AMENDMENTS TO THE DRAWINGS:

REMARKS

Though Applicants disagree with the Examiner's objection to the title, Applicants have amended the title to read: "Decoding Method, Decoding Apparatus, and Program to Decode Low Density Parity Check Codes."

FIG. 1 - Prior Art

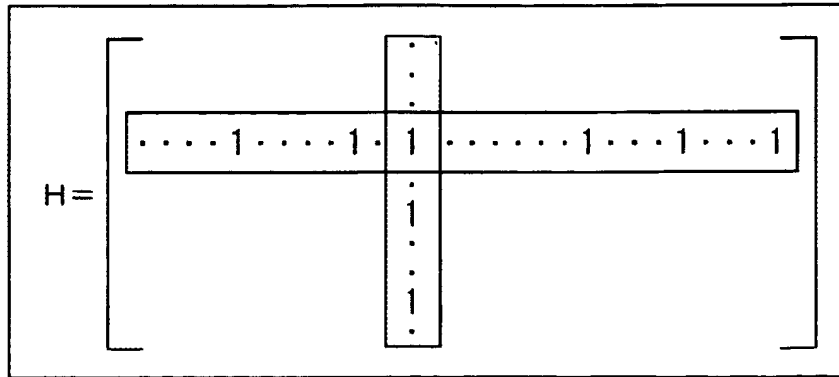
Applicants respectfully request reconsideration and withdrawal of the objection to the drawings. The drawings comply with 37 C.F.R. § 1.83(a) because Applicants have amended Figures 1-8 as suggested by the Examiner on page 2 of the outstanding Office Action. Specifically, Applicants have amended Figures 1-8 to include the label "Prior Art."
